CITY COUNCIL MEETING

Grimes City Hall
101 NE Harvey Street
February 9, 2016 at 5:30 pm

Grimes Mini Storage – Site Plan

Lot 2 Wal-Mart's Second Addition – Site Plan

HERITAGE AT GRIMES PLAT 4
GRIMES, IA
PRELIMINARY PLAT

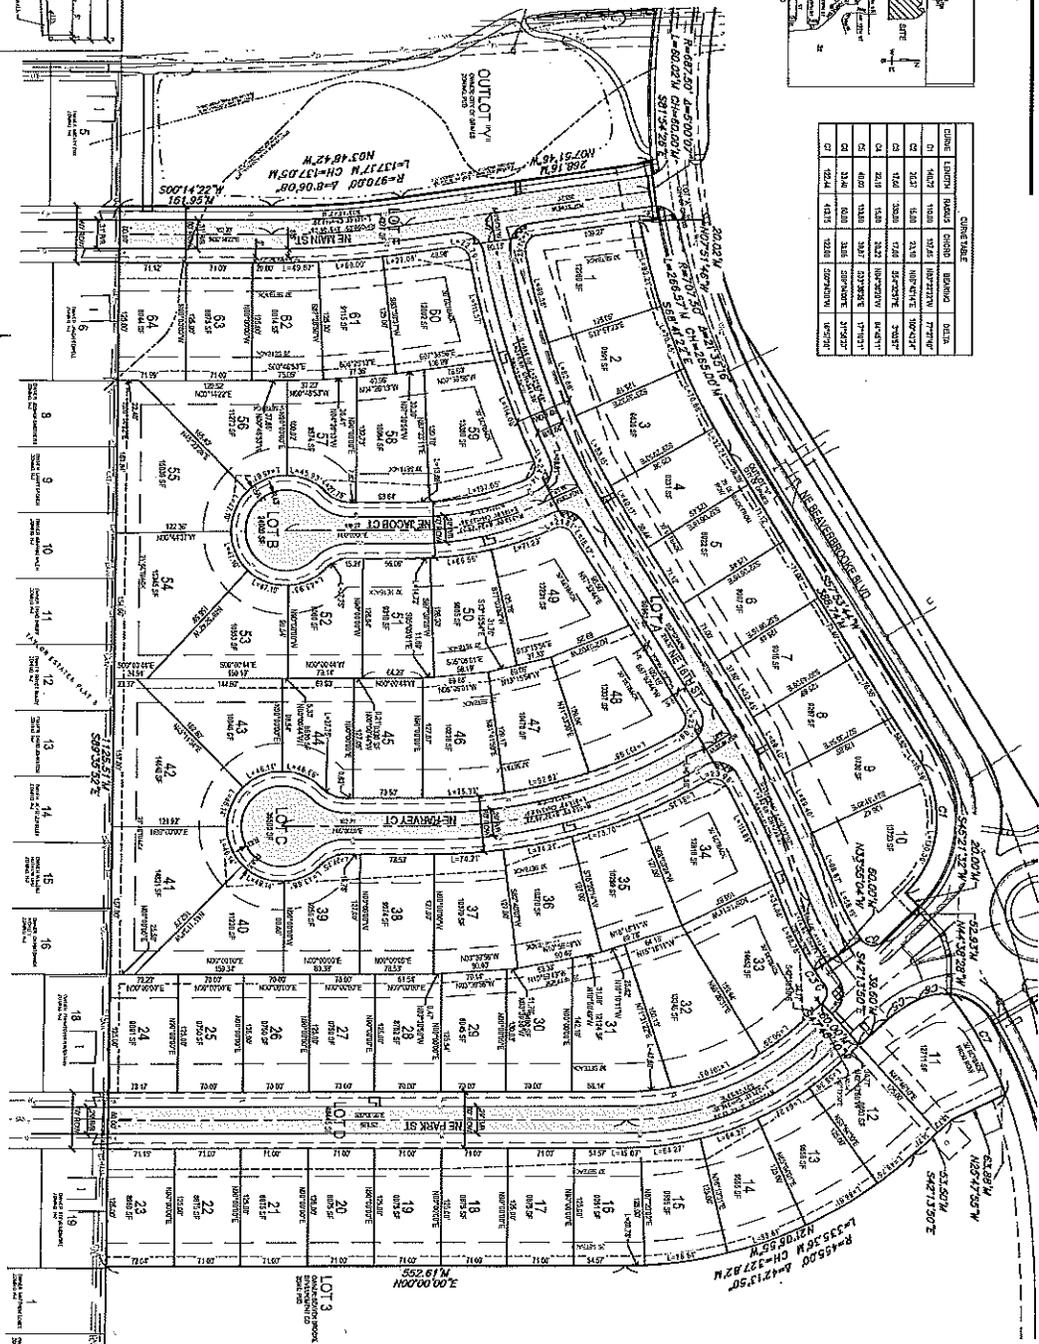
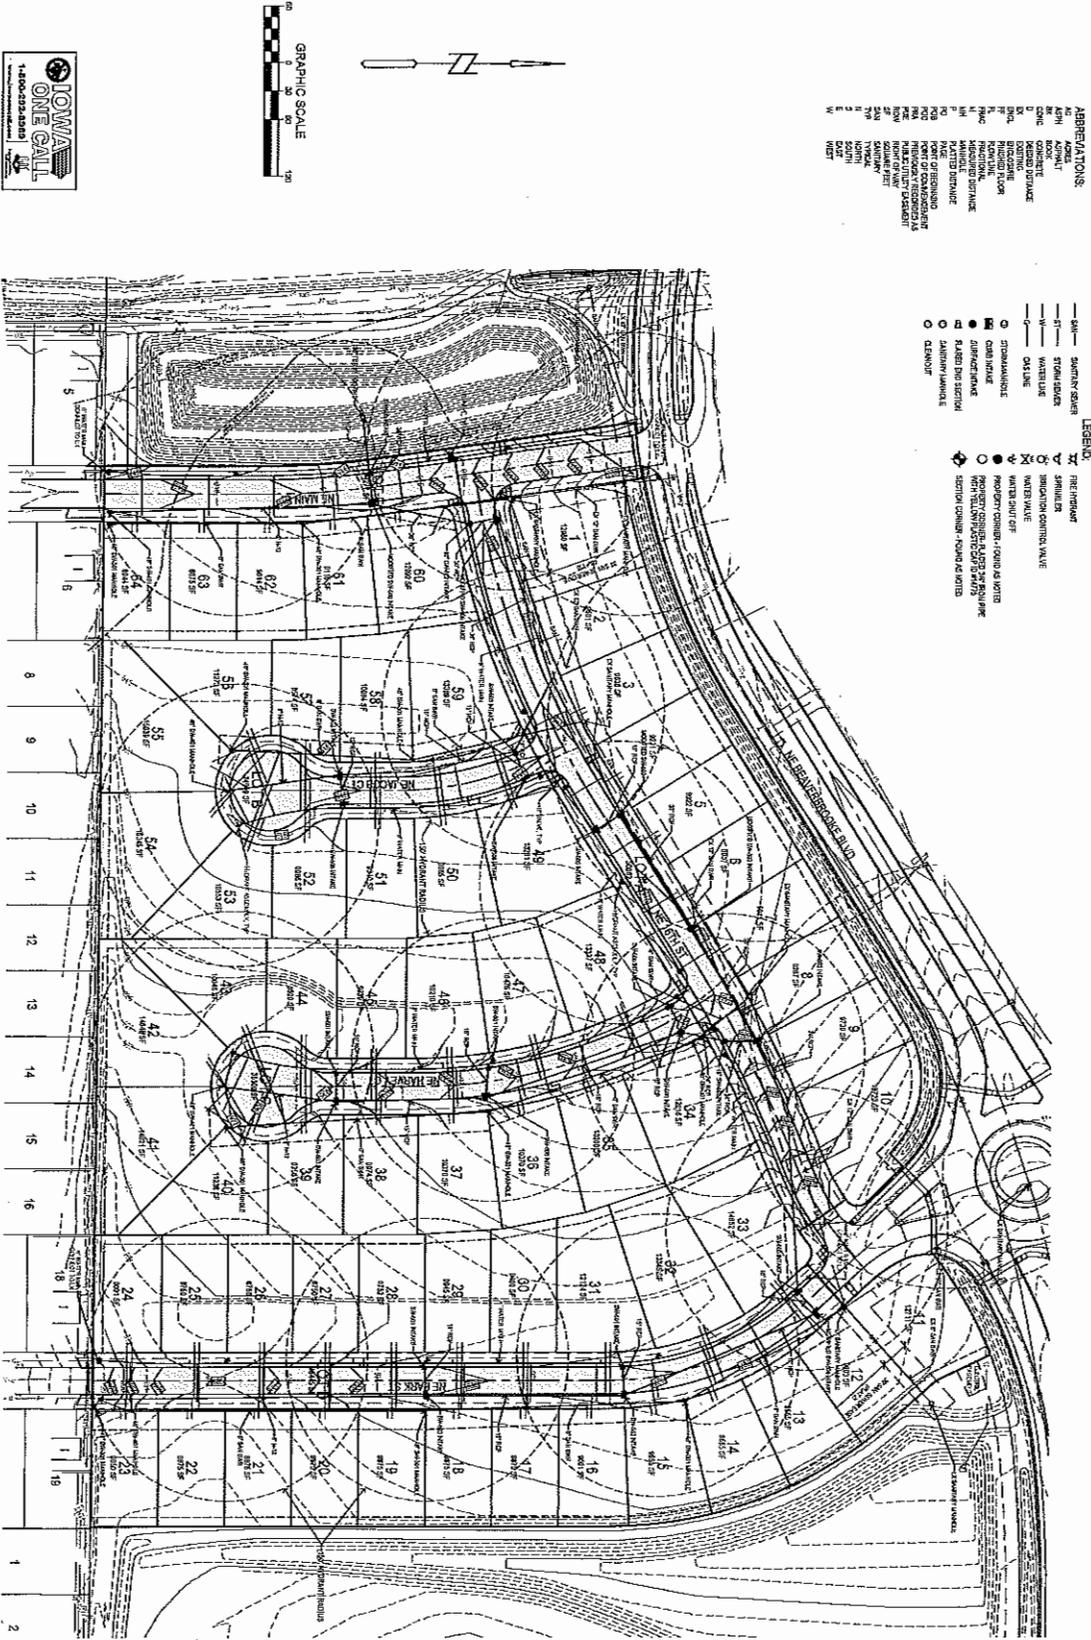
1. Please provide the geotechnical report once it is complete. Pavement design shall be as per the report.
2. Please move the setbacks linework along the "NE Beaverbrooke Blvd Outlot" to the easement line.

3. There is concern about the grading for this subdivision as it appears that a majority of the lots drain onto adjacent lots (a general east to west drainage pattern). For this to work correctly without drainage issues on the lots that are downgrade, more direction should be given to the lots so that they are built high enough with swales in the setbacks to convey drainage. It looks like the worst case scenario is for Lots 53 & 54. Please provide language on the preliminary plat that addresses the drainage pattern that will be required by the builder to convey drainage stormwater from backyard to front yard within the lot for those lots that are downgrade (and receiving stormwater) from other lots.

6. FOX has reviewed the plan in regard to the proposed sanitary sewer within the development in relation to the comprehensive plan and have the following comments:

Dimension and Utility Plan - Sheet 3 of 5

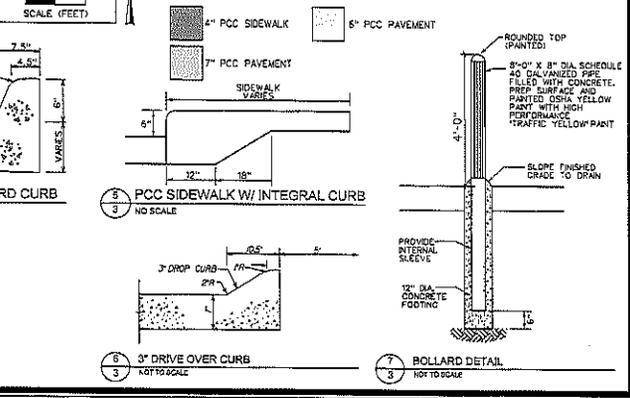
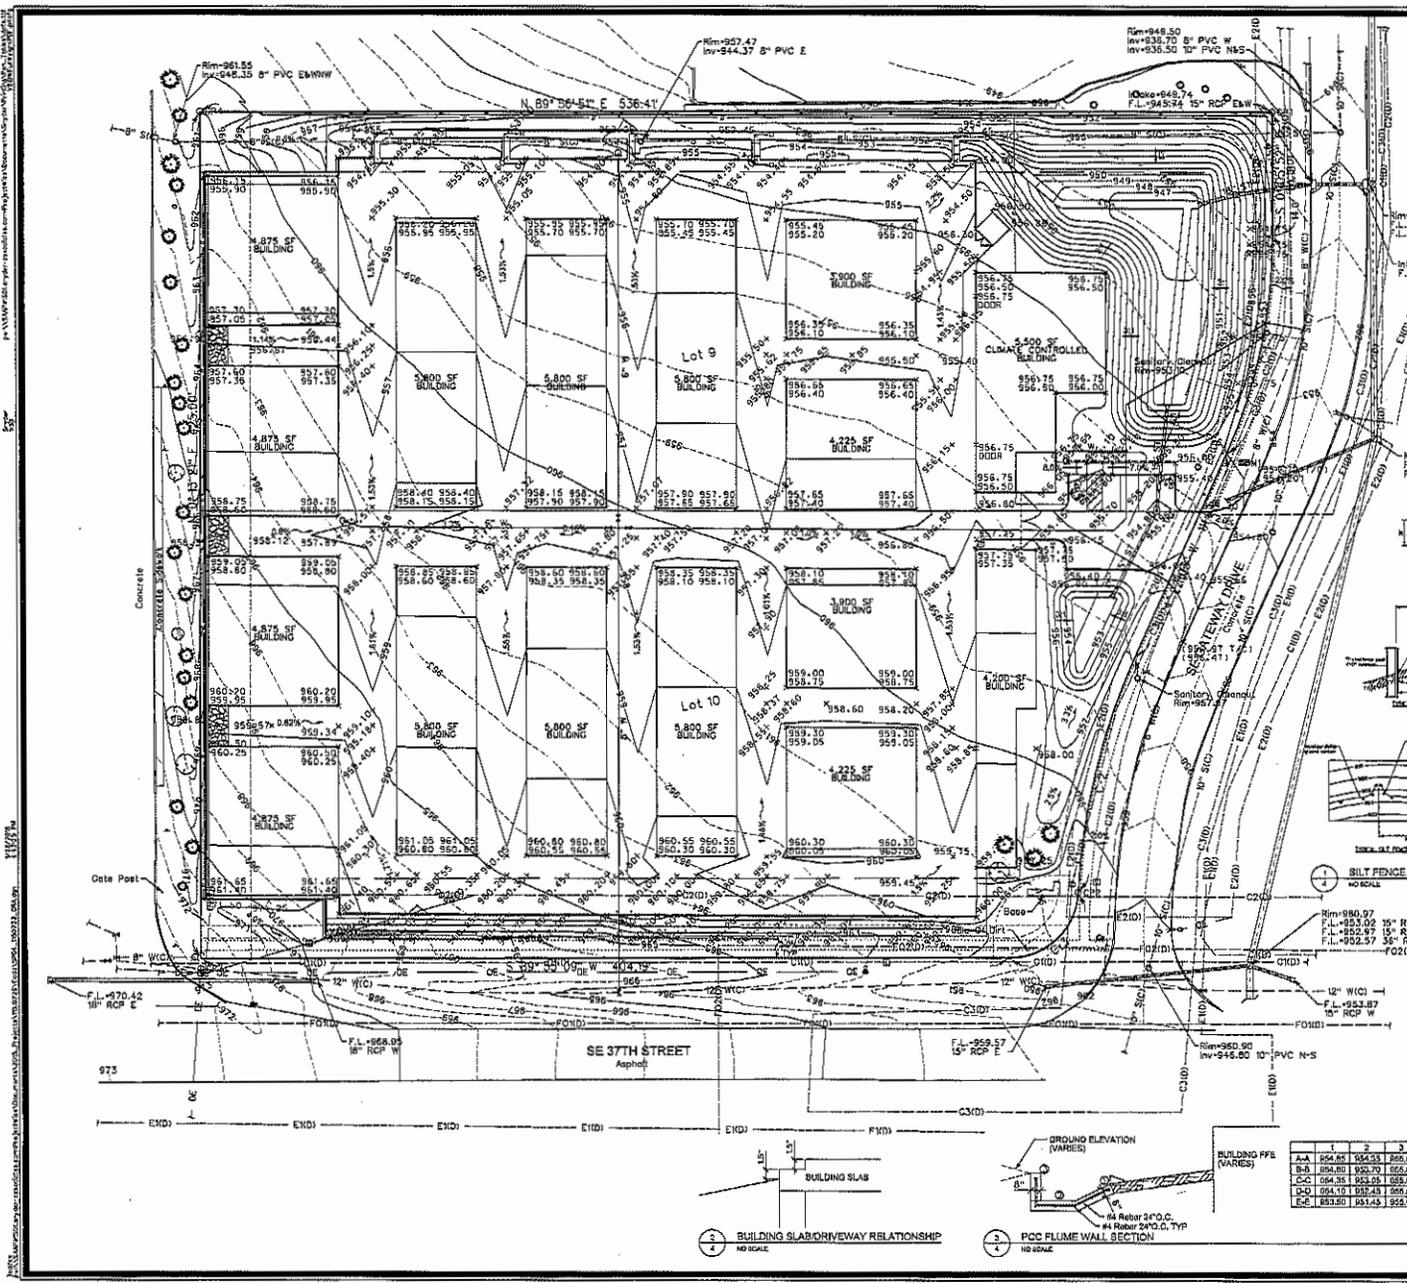
3. Please dimension the office space part of the building.
4. Please provide easements for the interior water mains on the site. This water main connects two important water mains together and also, an easement will allow city staff to maintain the fire hydrants.

Architectural/Elevation Plans

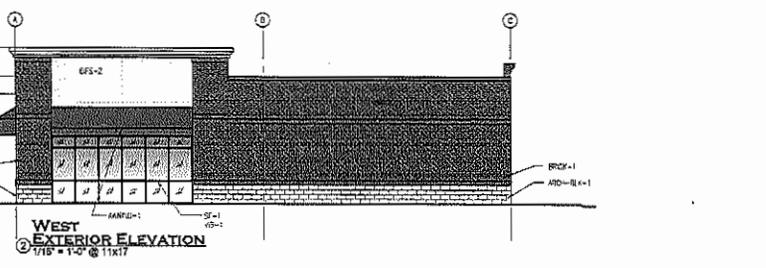
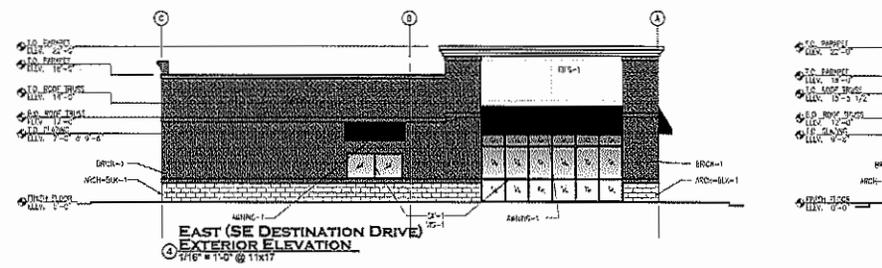
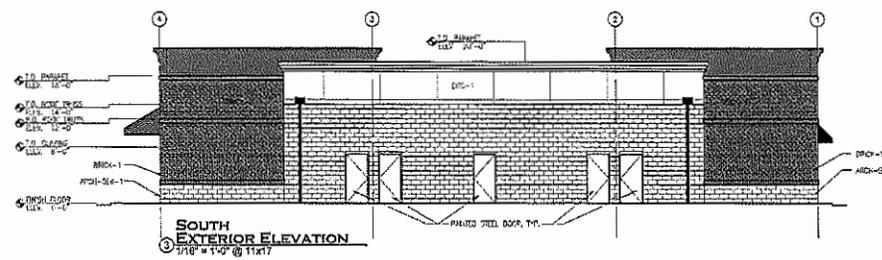
6. Typically, EIFS is not allowed in the Highway 141 and Highway 44 corridor; however the city has allowed small amounts of EIFS in the past. The current elevation plans have too much EIFS. Please consider revising the building plans prior to the P&Z and Council Meeting. In addition, please state the amount of building material percentages on each side of the structure. Please verify that all exterior building walls facing adjacent streets are glazed along a minimum of 40% of the wall length of clear glass at eye level.
7. It is highly recommended that you bring detailed building materials and color schemes with you to P & Z.
8. Note: a separate permit is required for any signage on the site. Also, the signage must meet the requirements of the Grimes Code (165A.26).
